APPLICATION OF KENTUCKY UTILITIES)	
COMPANY FOR AN ADJUSTMENT OF ITS)	CASE NO.
ELECTRIC RATES AND FOR CERTIFICATES)	2016-00370
OF PUBLIC CONVENIENCE AND NECESSITY)

RESPONSE OF
KENTUCKY UTILITIES COMPANY
TO
KENTUCKY CABLE TELECOMMUNICATIONS ASSOCIATION'S
FIRST REQUEST FOR INFORMATION
DATED JANUARY 11, 2017

**Response to Kentucky Cable Telecommunications Association's
First Requests for Information
Dated January 11, 2017**

WIRELESS ROUTER INSTALLATION

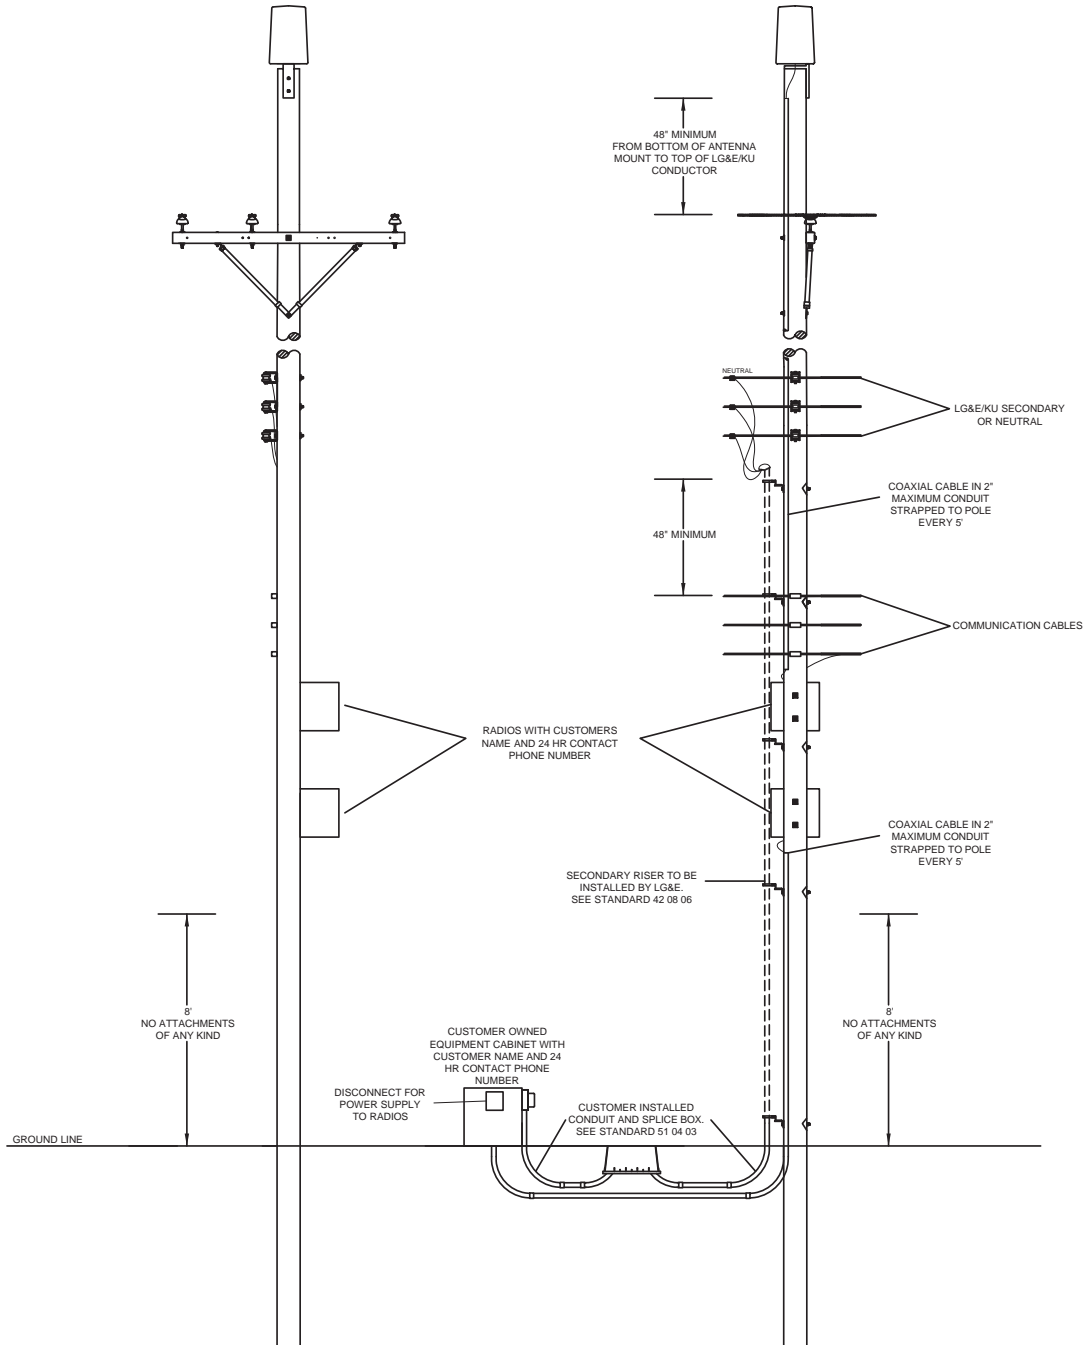
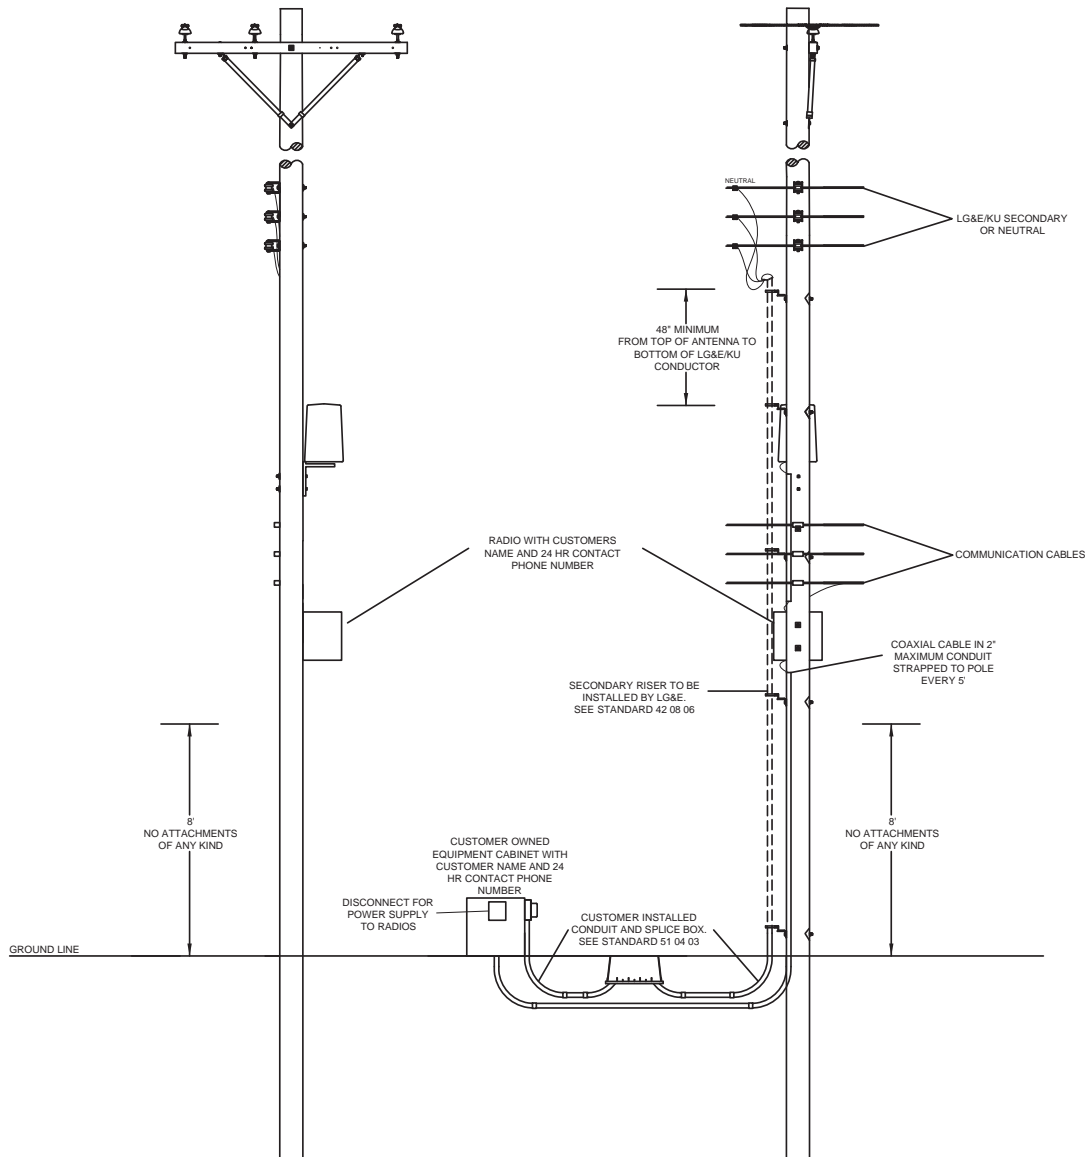
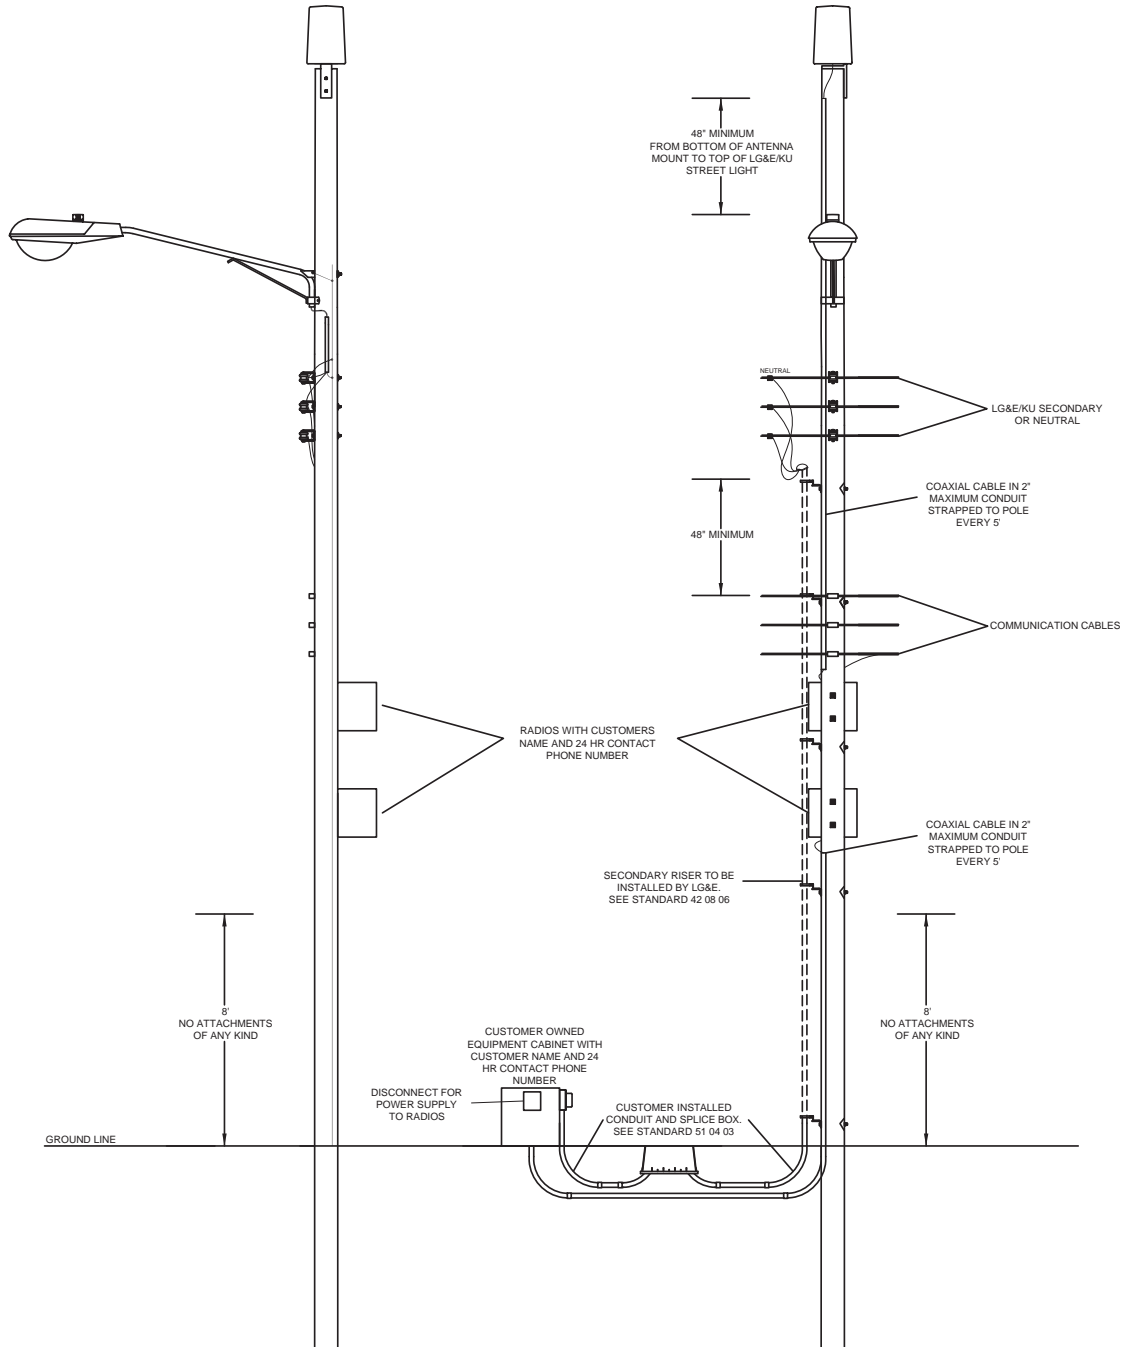
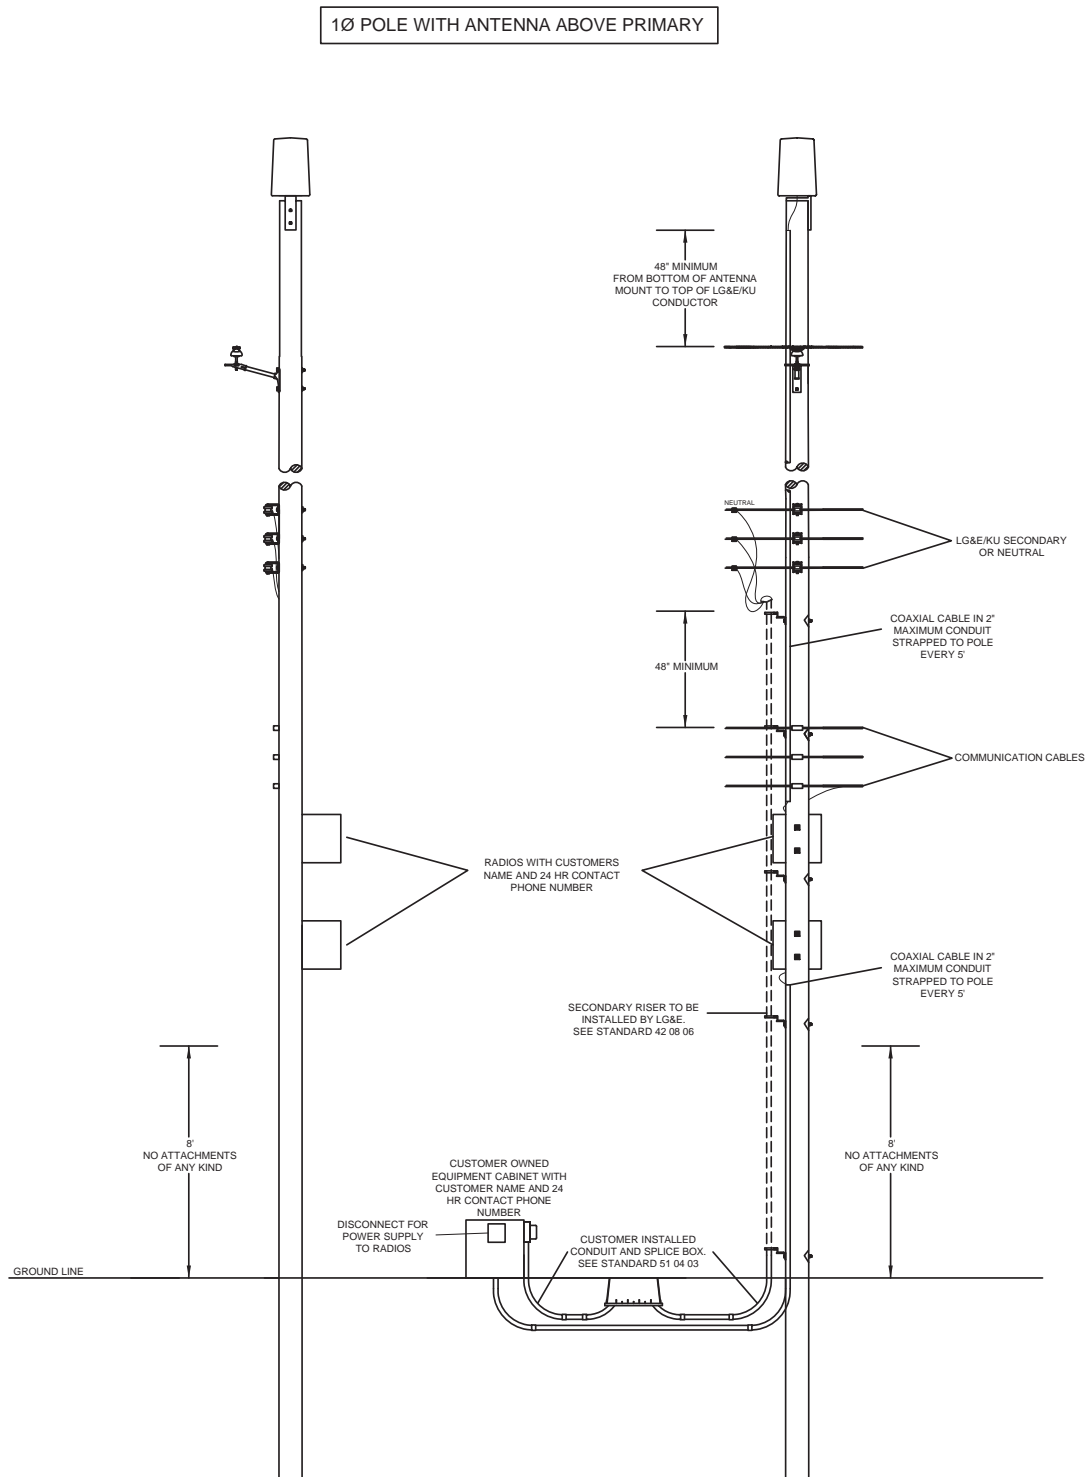
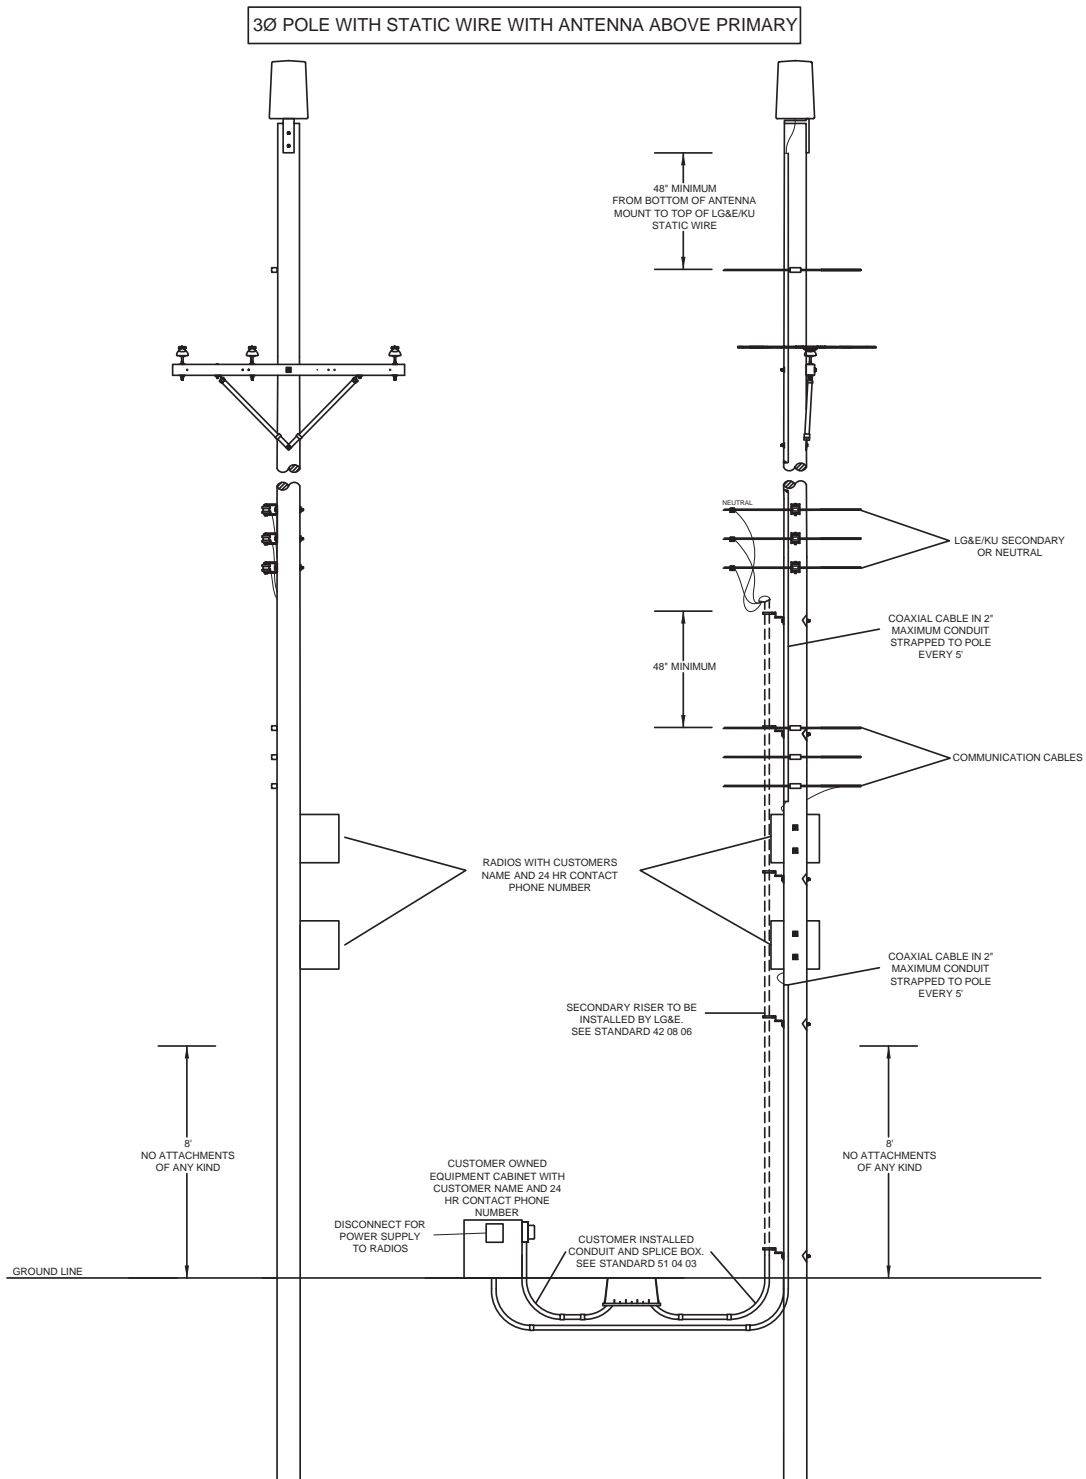
Q-1-16. Please provide a copy of all of Your standards and specification related to the design, installation, and maintenance of Attachments with which You propose Attachment Customers must comply.

GUIDELINES FOR DESIGN AND INSTALLATION

- Consult Distribution Operations Design Group to ensure that 120/240 volt service is available on the pole in question.
- All installations must conform to all applicable electrical codes and LG&E/KU requirements for clearances, climbing space and working space.

- The antenna power source must have an additional lockable disconnect installed to allow the antenna and radio/equipment boxes to be disconnected from the battery backup before work is performed within the area designated by the RF Warning signs. Each disconnect must provide a visible break, a test point, or similar means for utility workers to ensure circuit has been de-energized. Each attaching company shall provide and install a lockbox with a key to their disconnect switch inside. LG&E/KU will padlock the lockbox to enable access to the attacher's key for the disconnect switch.
